Technical Service Information

FORD 5R55N NEW DESIGN PAN GASKET

Figure 1

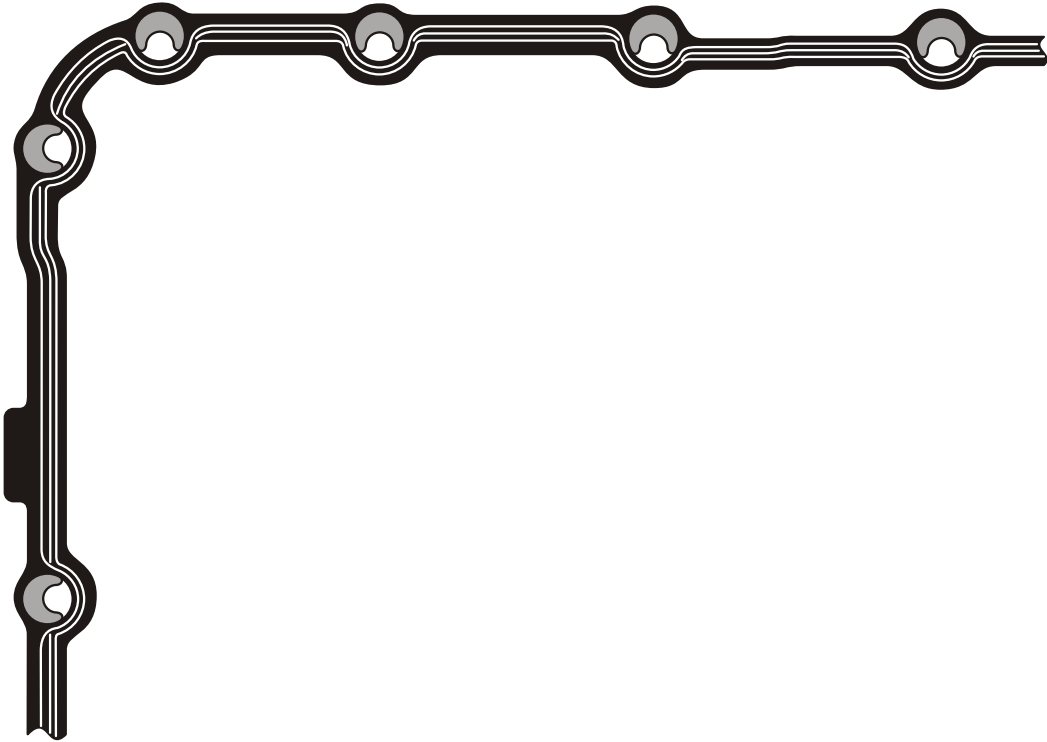
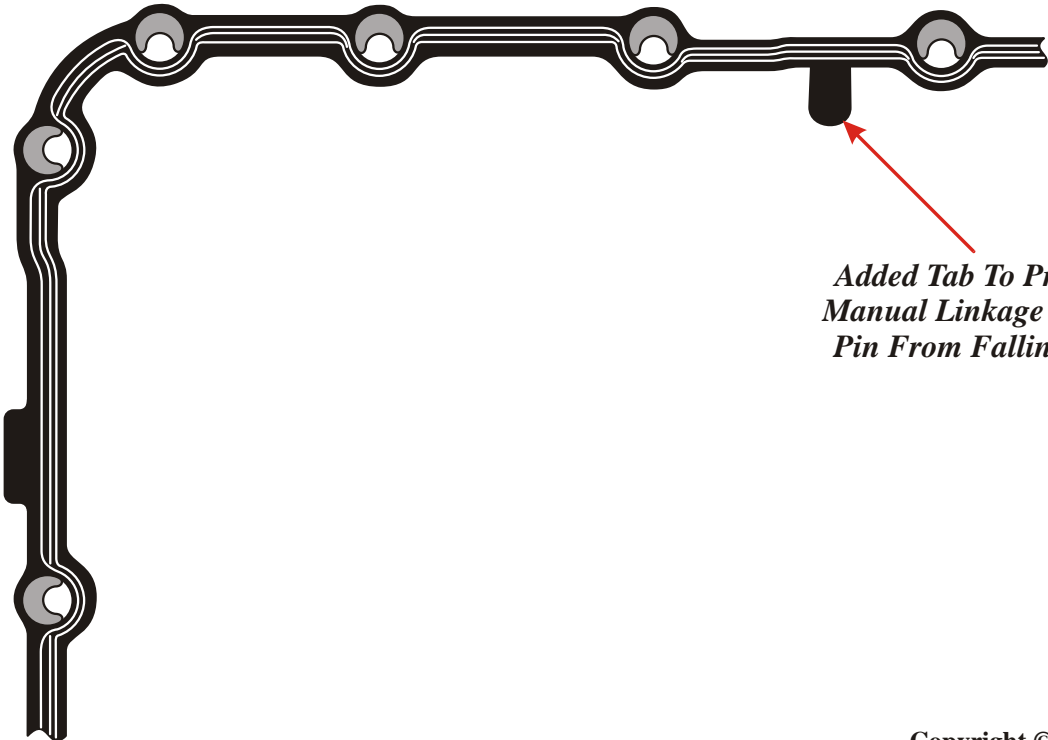
CHANGE: Ford Motor Company has implemented a new design pan gasket as a running change during the first few months of production, with a "Tab" added to the gasket, as shown in Figure 1.

REASON: To prevent the roll pin that retains the manual shift lever from falling out.

- (1) PAN GASKET - This gasket is the same design as the AX4S/AX4N, with a plastic core and molded rubber sealing surface. Revision was made to the plastic core with the addition of the "Tab", as shown in Figure 1.

**FORD 5R55N PREVIOUS DESIGN PAN GASKET
(NOT RECOMMENDED FOR USE)**

**FORD 5R55N CURRENT DESIGN PAN GASKET
PART NUMBER XW4Z-7A191-CA**

*Added Tab To Prevent
Manual Linkage Rolled
Pin From Falling Out*

The new design pan gasket should be used on all models of the Ford 5R55N transmission. Failure to use the pan gasket with the added "Tab", may result in loss of vehicle control and/or gear selection, including Park.

Pan Gasket (New Design) XW4Z-7A191-CA
